Yealink T3X-V70 Release Notes

1. Firmware Version: 38.70.0.105 upgrade to 38.70.0.115
2. Product Name: SIP-T38G
3. Release Date: January 5, 2013

1. Added "HD" icon on the call interface when codec is set as G.722

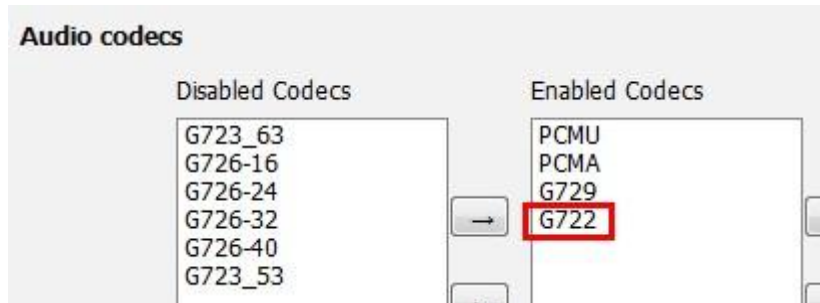
Instruction: Configure the codes as G.722. When establishing a conversation, it will display a "HD" icon at the top right corner of the dialing interface, as the pictures shown below.

3. Added Base Mode of Hot Desking function

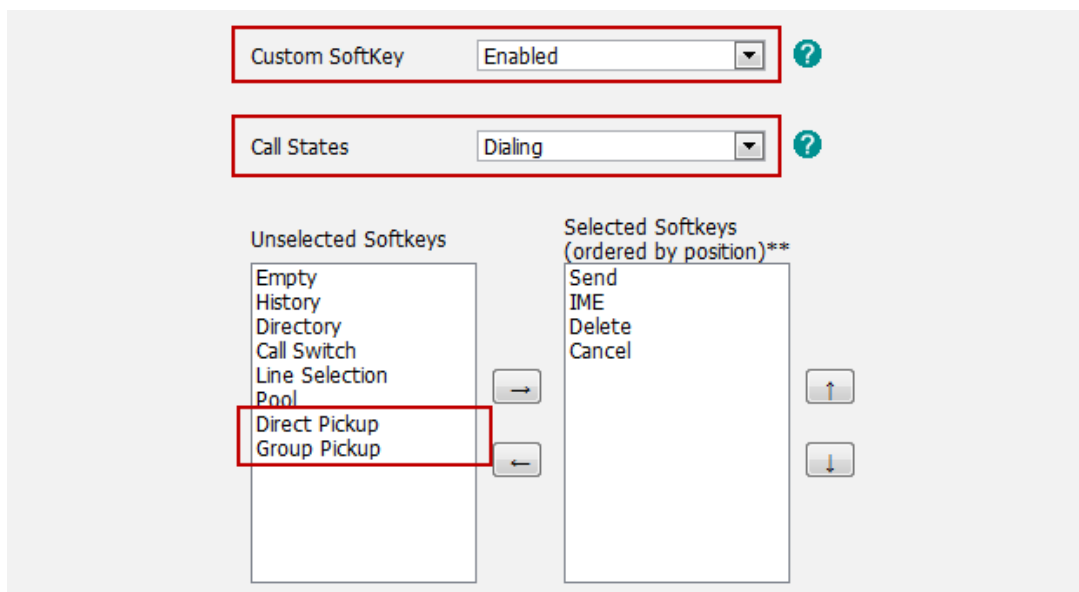
Instruction: For the details, please refer to “Yealink SIP-T3xG User Guide.pdf” about Hot Desking function.

LCD pops up a warning box showing below:

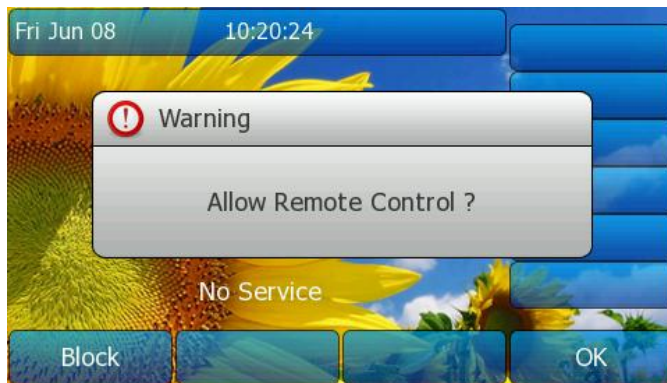
When it is configured with a specific IP address and the host machine (with the IP) executes an Action URI command to control the device, T3x LCD will pop up a warning box reminding you whether allows the device to be remote controlled or not?

- 1) If you press the “OK” key, the device will be controlled;
- 2) If you press “Block”, the device will block the control.
